## ***Interactive comment on “TerrSysMP-PDAF (version 1.0): a modular high-performance data assimilation framework for an integrated land surface–subsurface model” by W. Kurtz et al.***

Interactive comment on Geosci. Model Dev. Discuss., 8, 9617, 2015.

**Fig. 1.** Simulated soil water content at four verification nodes ( $x=2500\text{m}$ ,  $y=1500/2500/3500/4500\text{m}$ , from north to south) for April–June 2013. Upper row: open-loop simulations; lower row: assimilation.

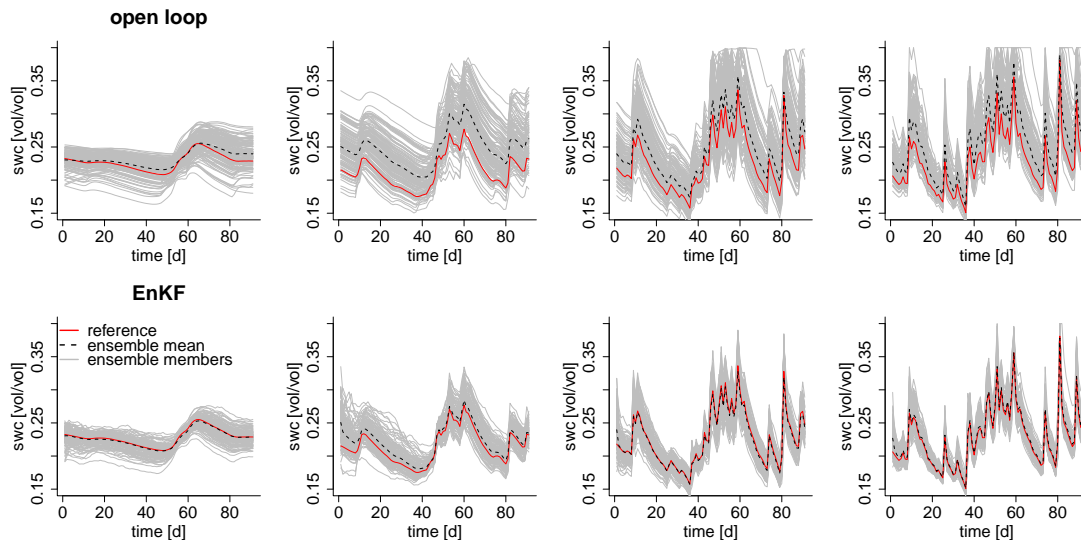
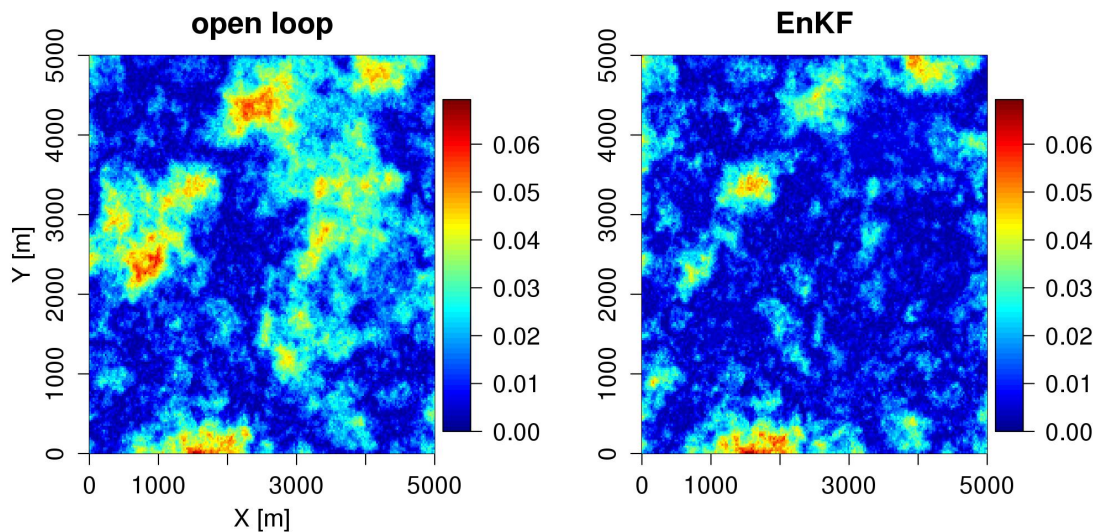
P9643, line 6-7: “This can again be related to the lower observation density at the model borders.” I agree with authors’ explanation. However, why it does not occur in other boundaries? The results present in Fig 9 are based on four points from north to south at  $x=2000\text{m}$ . Based on my previous comments and suggestions, it would be nice if you can select different points other than  $x=2000\text{m}$  and examine the results. This could also verify your explanation of the boundary issue.

**Reply:** In fact, this phenomenon can also be observed for the boundary grid cells of the western and the eastern face of the model domain. The only difference is that the magnitude of AAE is larger at the southern and northern boundary. Please note, that there were problems in the calculation of the AAE fields in Fig. 10 (see below). However, the spatial patterns of AAE still remain, only the magnitude changed slightly. For Fig. 9, we also checked four independent points for verification which are in between the observation points ( $x=2500\text{m}$ ,  $y=1500/2500/3500/4500\text{m}$ ). However, the conclusions for these different verification points are quite similar to the ones from the previous figure (see Fig. 1 below). We will show the results from the independent verification points (see Fig. 1 below) in the revised manuscript.
